**Re: Proposed works at 52 Tottenham Street, London affecting 30 Cleveland Street, London –
Daylight & Sunlight – Planning Reference: 2020/3043/P**

I refer to your recent instruction where you have asked us to consider the likely impact on overshadowing to your two roof terraces to the north west of the proposed development at 52 Tottenham Street, London.

Title:
 2-hour sun-on-ground contour
 21st March
 EXISTING + PROPOSED

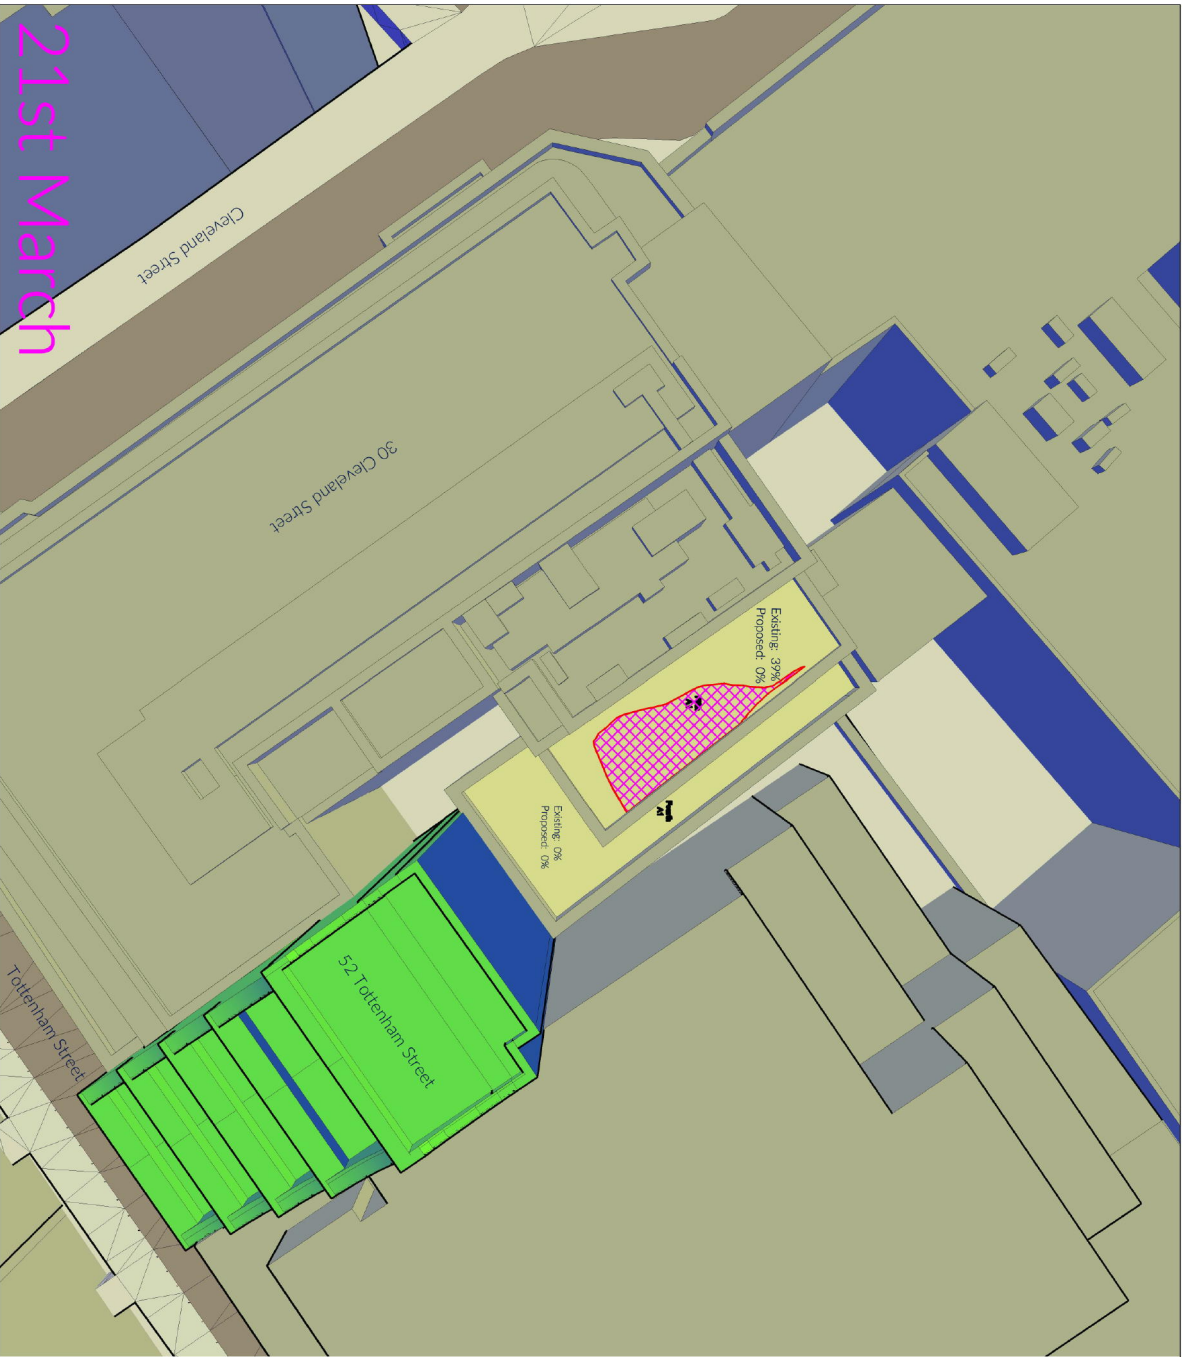
Attached to this report are our illustrative plots that show the areas of loss (hatched in magenta) in all months ranging from 21 March to 21 August. This is so that it is possible to understand the proposed impact throughout the fair weather months, which is the time in which the space gets used the most.

As it can be seen from the above table, and the illustrative plots attached, there is likely to be an extremely high amount of unacceptable harm caused to both the amenity areas in question rendering the fourth floor area not achieving 2 hours of sun in any of the months considered above. Furthermore, only May, June and July will see 2 hours of sun on the fifth floor area, but they will be well below the target of 50% of the area at 11%, 26% and 12% respectively.

This, in our view, is a very significant impact and a clear indication that the scheme does not comply with Camden policy. Therefore, if the scheme was to achieve consent, then it is likely that each space specifically set aside for the health and wellbeing of your staff will be rendered unusable for its intended purpose and be completely overshadowed by the proposed development at 52 Tottenham Street.
